Invincible Colliery (PA 07_0127) and Cullen Valley Mine (DA200-5-2003) Modifications

I refer to your letter dated 25 March 2014 regarding the review undertaken by NSW Office of Water of the Environmental Assessment for the above mentioned Modification applications. To assist in addressing water related matters identified in the above correspondence and following on from our meetings on the 3rd and 30th of April 2014, Coalpac engaged specialist independent consultants *Australian Groundwater and Environment* (AGE) and *WRM Water and Environment* (WRM) to prepare the required supplementary reports. A copy of the supplementary reports to the Environmental Assessment for groundwater and surface water are attached for your reference.

RE: INVINCIBLE COLLIERY AND CULLEN VALLEY MINE MODIFICATIONS SUPPLEMENTARY GROUNDWATER REPORT

**SUBJECT: INVINCIBLE COLLIERY & CULLEN VALLEY MINE MODIFICATIONS
SUPPLEMENTARY SURFACE WATER ASSESSMENT**

Figure 1: Cullen Valley Mine & Invincible Colliery Water Balance Schematic

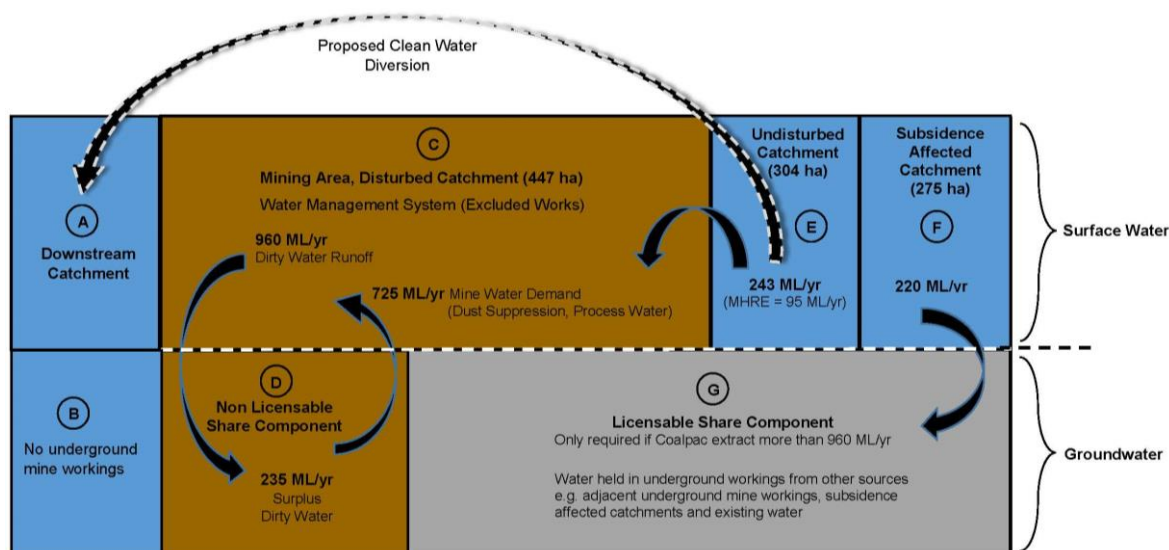
- WRM 2014 (see attached) identified that in the absence of appropriate management and mitigation measures, Coalpac would likely require Water Access Licences for the average take of approximately 148 ML per year (243 ML/yr – 95 ML/yr) of surface water from undisturbed catchment areas under the *Macquarie Bogan Unregulated and Alluvial Water Sources Water Sharing Plan*. Coalpac's harvestable rights have been estimated to be 95 ML per year (See **Figure 1**).

- WRM 2014 (see attached) estimate that water directed to the Old Invincible and Invincible underground workings from the existing and proposed disturbance areas at Cullen Valley Mine and Invincible Colliery will exceed site water demand requirements. This will generate a surplus of 'dirty water runoff' stored in the mine water management system and underground workings of up to 235 ML/yr on average (see **Figure 1**).

Figure 2-1: Area of Potential intersection of Flooded Workings

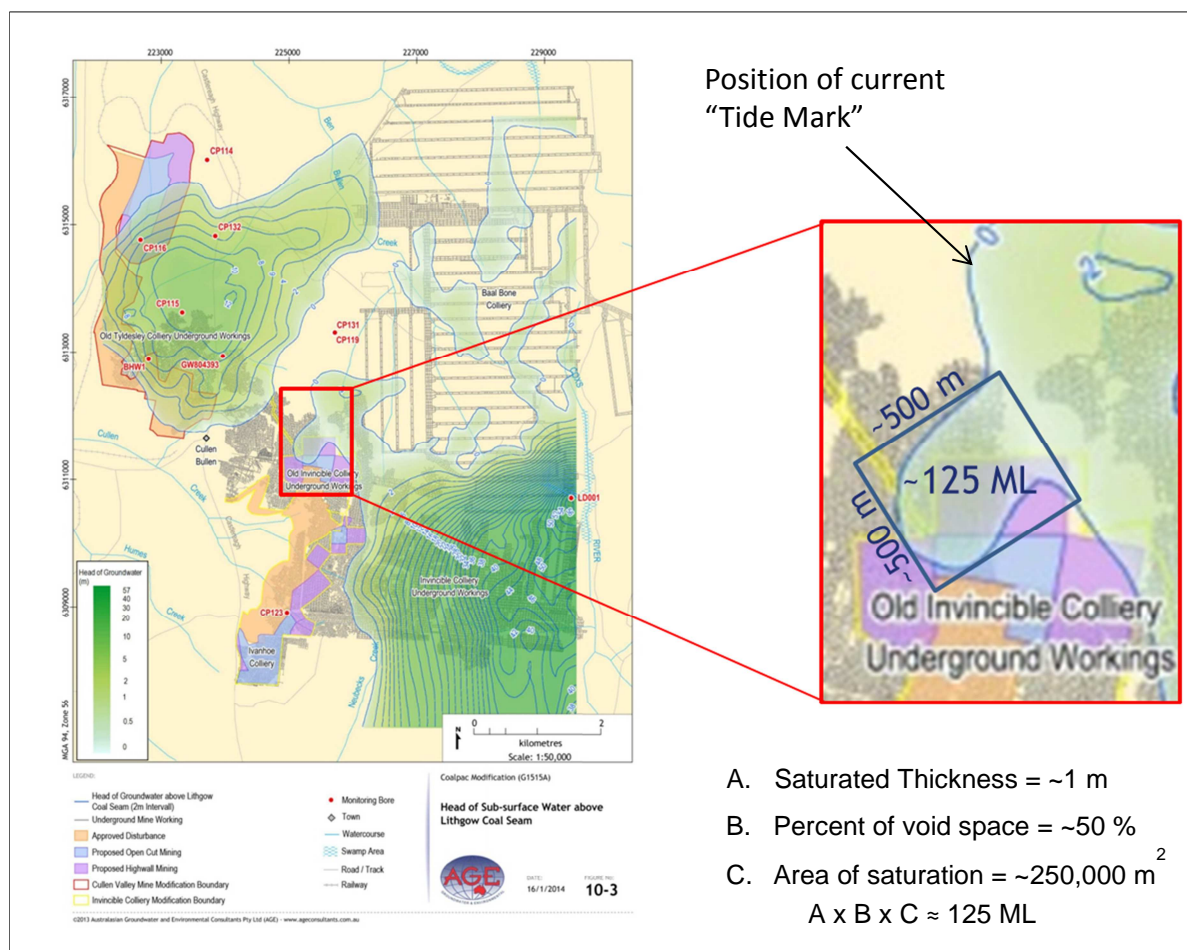
A small area in the proposed Northern open cut pit area at Invincible Colliery may encounter partial saturation of the Old Invincible Colliery underground workings. Figure 2-1 shows this area in more detail.

One of these coal seam depressions is located in the northern portion of the Modification Boundary at Invincible Colliery. The blue polygon shown in Figure 2-1 defines the proposed open cut pit which is planned to mine down into the Lithgow Seam. The purple polygon shows the proposed highwall mining areas which are planned to extract all seams located above (the nearest seam is 15 metres above) the Lithgow Seam. The seams located above the Lithgow Seam are unsaturated.

A very shallow depth of water (<0.15 m) separates the depression from the main body of the flooded workings, located towards the east. The proposed northern portion of the Modification Boundary at Invincible Colliery is located near the outer limits of the depression, and is predicted to intersect a saturated depth of about 0.5 m within the flooded workings.

The total volume of water stored within the coal seam depression located near the proposed northern portion of the Modification Boundary at Invincible Colliery can be estimated by first calculating the open area of the depression and multiplying this area by the height of the water body within the workings. The depression is roughly square, having lengths equal to about 500 m. The underground workings were mined with bord and pillar methods, which left about 50% of the coal seam in-place to support the roof. Therefore, the total area of the open void within the depression is estimated to be $125,000 \text{ m}^2$. If a conservatively high saturated thickness of 1 m is used, the total volume of water stored within the underground workings in the depression located near the proposed northern portion of the Modification Boundary at Invincible Colliery is about 125 ML.

Figure 2-2: Modification Areas and Box-Gum Woodland Communities

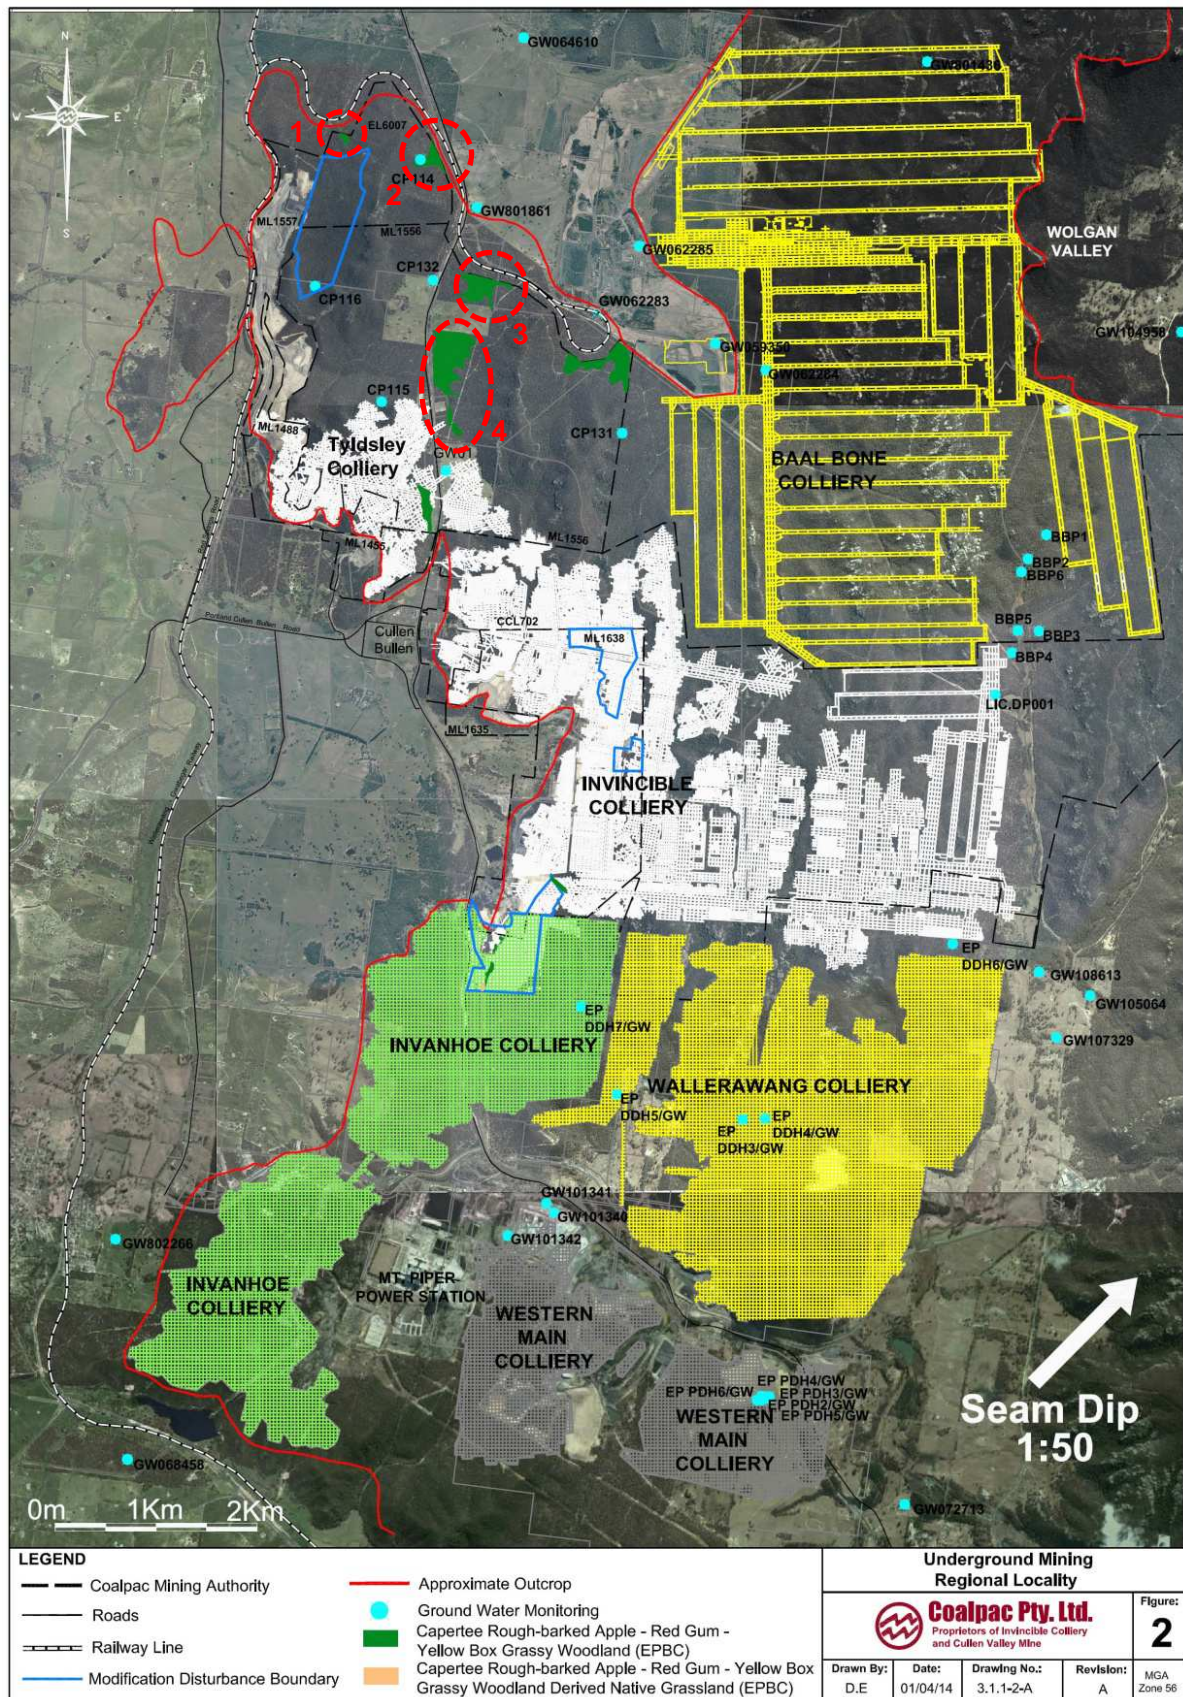
Box-Gum Woodland has been identified outside the Modification Boundary at Cullen Valley Mine at four locations³. Figure 2-2 shows the four locations where this community has been found.

The depth to the groundwater table ranges between 20 m and 50 m beneath the topographic surface at each of the locations where the Box-Gum Woodland occurs. The depth of the water table at each location is summarised in Table 1.

The vertical distances separating the topography and the groundwater table are therefore sufficient to prohibit the root system of the woodland community from directly tapping the regional groundwater table. Any perched groundwater that may be locally present will not be impacted by the proposed Modifications.

Figure 2-3: Distance Drawdown Relationship

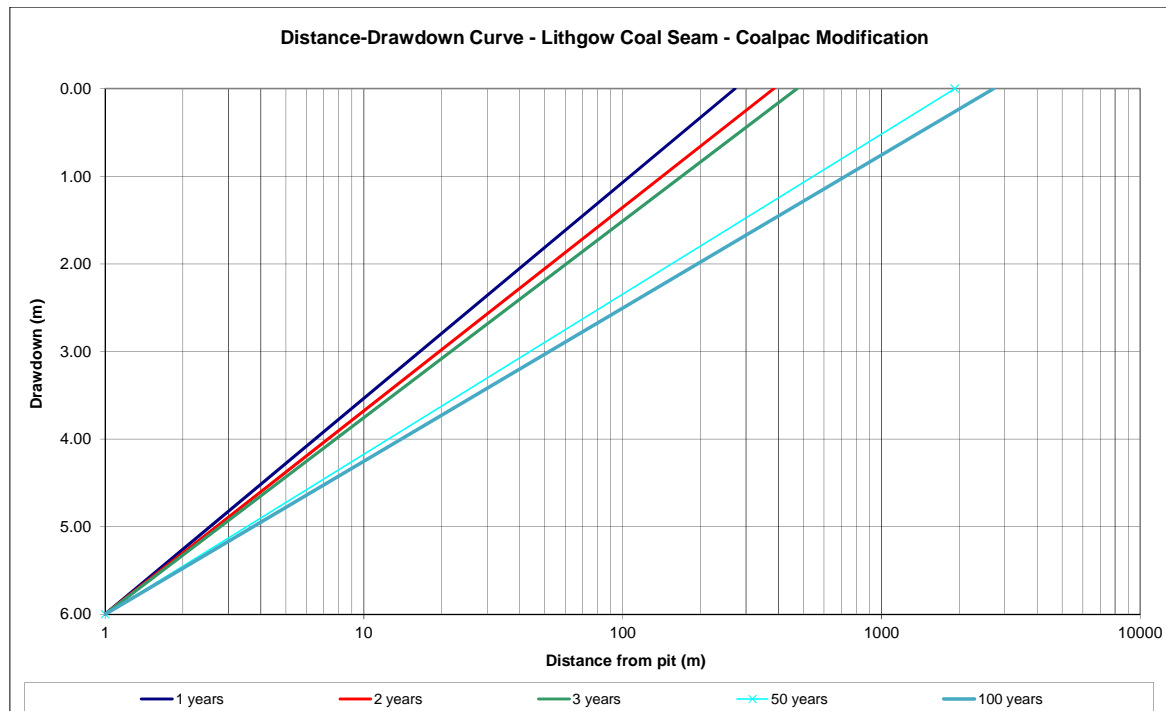
The extent of drawdown was calculated for five time steps, these being after year 1, 2, 3, 50, and 100. A single representative value of hydraulic conductivity 0.09 m/day was multiplied by a coal seam thickness of 2.5 m to derive a transmissivity of 0.225 m²/day. A storage coefficient value of 0.0025 was used to represent the confined to semi-confined nature of the shallow coal seam. Figure 2-3 presents the predicted distance-drawdown curves.

The results predict the extent of drawdown resulting from the proposed Cullen Valley Modification Disturbance Boundary will expand to about 500 m after about three years of mine operation. The hydraulic gradient produced by the drawdown will be about 0.012.

Figure 2-4: Neighbouring Registered Bores

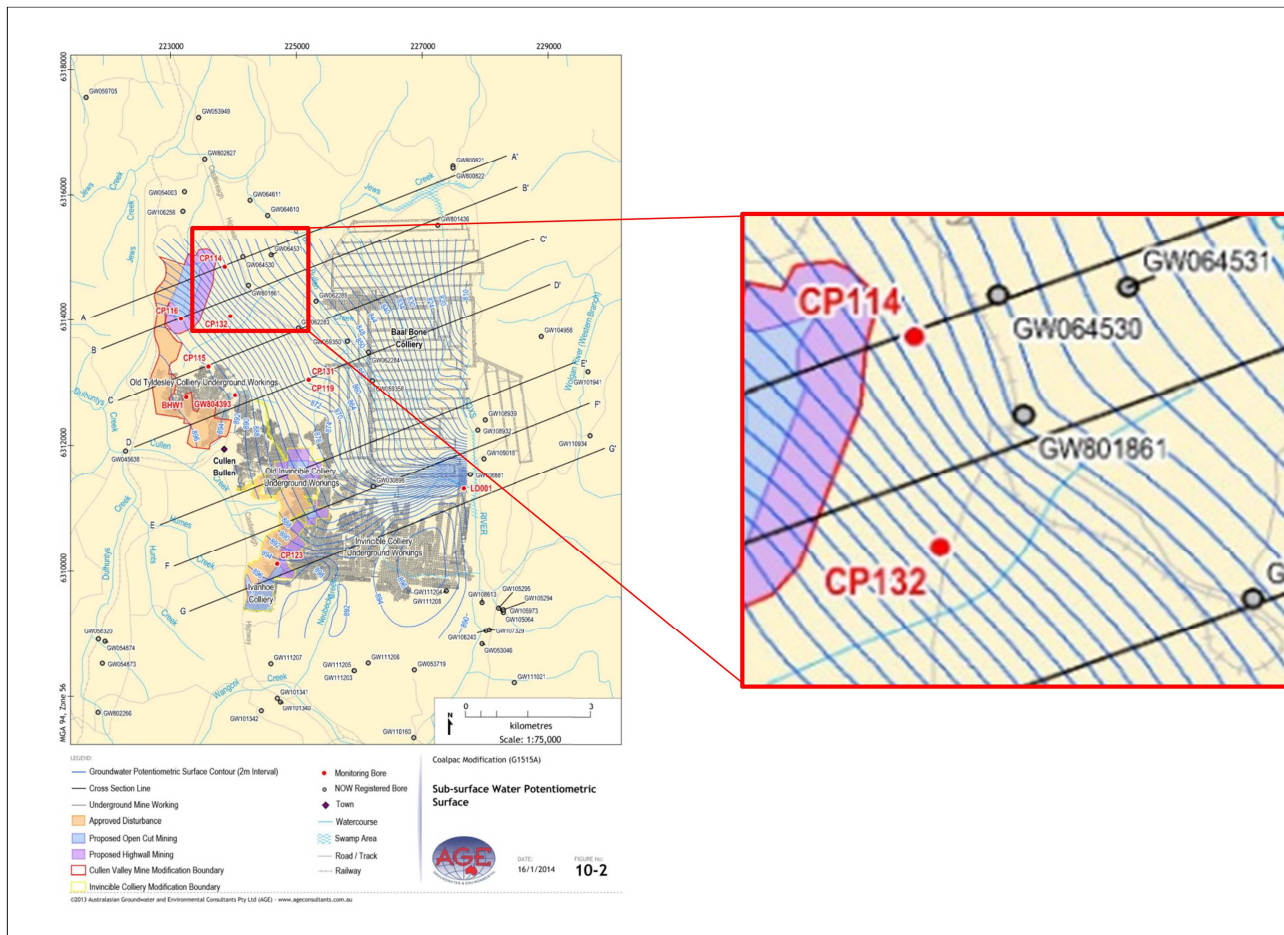
There are no privately registered bores located within the predicted zone of aquifer depressurisation surrounding the Cullen Valley Mine Modification Boundary. Figure 2-4 shows the location of neighbouring registered bores in more detail.

GW801861 was drilled as a test bore and it's licence has been cancelled. GW064530 and GW064531 are active and are used for stock and domestic purposes. Table 7 summarises details for each of these neighbouring bores.
